Detailed Site Plan
Departure from Design Standards
Alternative Compliance
The Herman Apartments

DSP-22017
DDS-24003
AC-25009

STAFF REPORT

SUBJECT: Detailed Site Plan DSP-22017
Departure from Design Standards DDS-24003
Alternative Compliance AC-25009
Type 2 Tree Conservation Plan TCP2-023-2025
Variance to Section 27-442(c)
The Herman Apartments

Figure 1: Site Plan

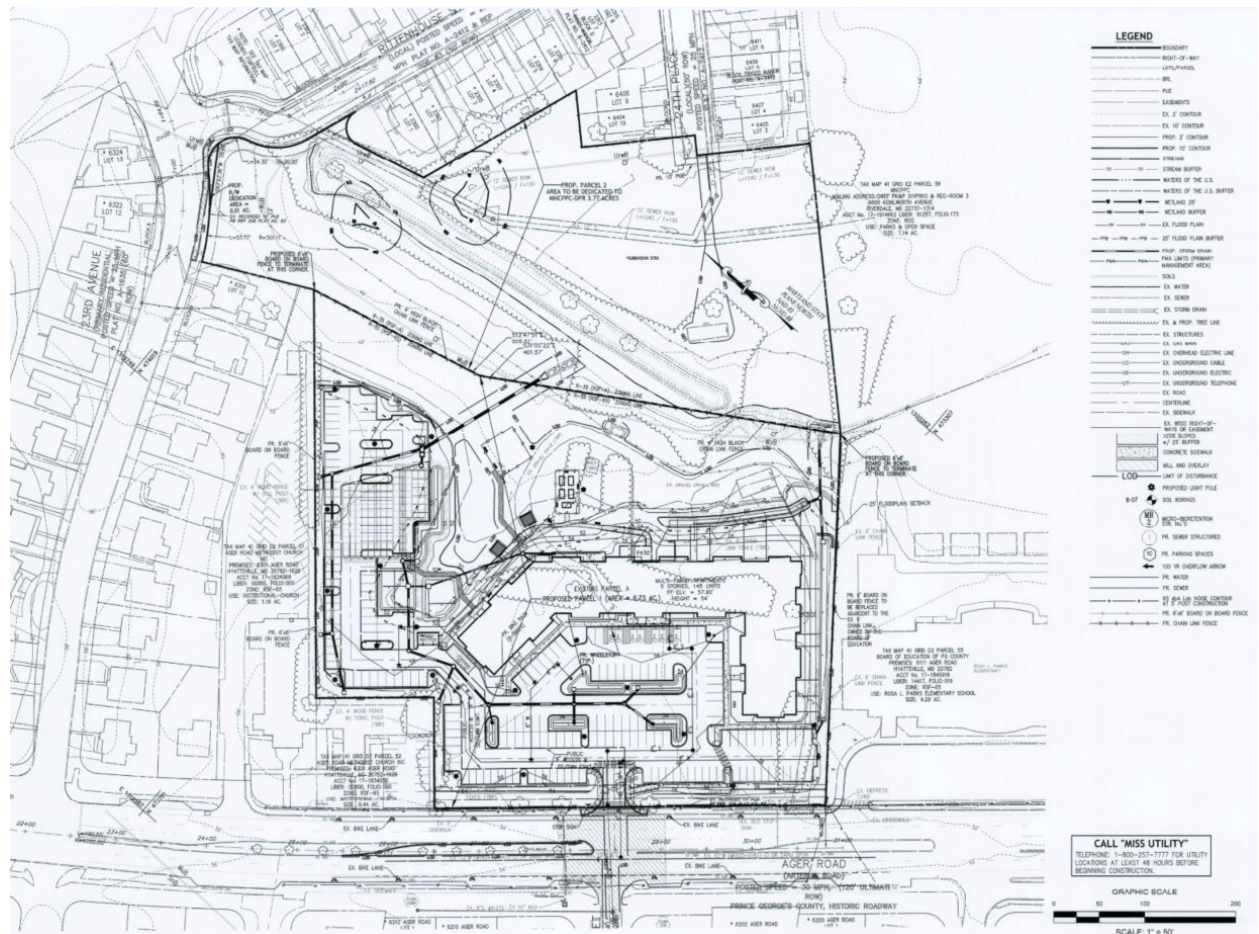
6. **Design Features:** The DSP proposes development of 145 multifamily dwelling units within one 5-story building, with one vehicular access driveway from Ager Road. The proposed multifamily building with associated infrastructure and amenities will be developed on the proposed Parcel 1. Proposed Parcel 2 will be dedicated to M-NCPPC, to add onto the stream valley parkland, located on abutting Heurich Park. Due to the existing environmental features on the northern portion of proposed Parcel 1, the proposed multifamily building on Parcel 1 will be located south of the 100-year floodplain and its buffer area, facing a parking area that will occupy the western and southern portions Parcel 1.

landscaping and internal sidewalks, providing pedestrian access to the parking area and amenities located at the rear of the building. Striped crosswalks are proposed at the vehicular entry/exit point and between proposed internal sidewalks and the sidewalks outside of the parking area for pedestrian connectivity. The dimension of the proposed sidewalk is not labeled on the DSP. A condition is included herein requiring the applicant to add dimensions to the proposed sidewalk surrounding the proposed building.

- f. Add dimensions to the proposed sidewalk surrounding the proposed building.
- g. Revise the front elevation and floor plan of the building to match.

Figure 5: Floodplain acreage comparison with surrounding properties

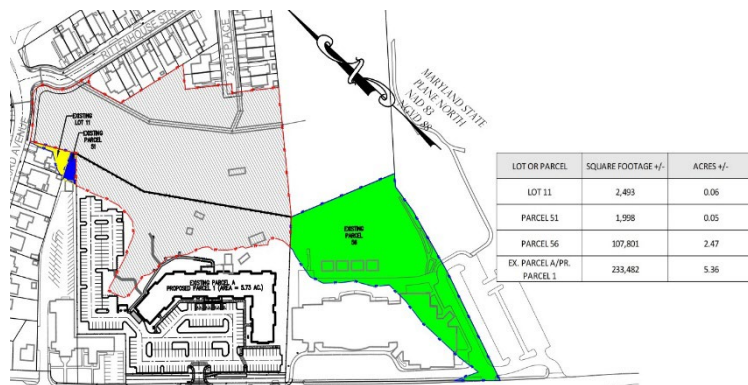
The applicant first claims that the property is encumbered by unique environmental features, specifically over half the site (55.8 percent or 5.36 acres) is covered by floodplain, streams, and wetlands. As a result, the existing environmental features reduce the net lot area (buildable area) of the site to only 4.15 acres. The applicant provides two exhibits to demonstrate that out of the approximately 600 tax accounts in surrounding properties, 32 properties are fully within the floodplain, and 39 are partially within floodplain; however, of the surrounding R-55 Zone, only 3 contain partial floodplain. Staff note that there are at least two other R-55-zoned properties wholly or partially in the floodplain along Powhatan Road. In addition, there are several other properties in residential zones, including the R-18 Zone under which this property is being evaluated, that are wholly or partially within the floodplain. Thus, the amount of floodplain on the property alone does not make it physically unique.

The applicant further provides a graphic showing the area of floodplain on the subject property (outlined in red), compared to the floodplain area on neighboring properties (shown in green, blue, and yellow).
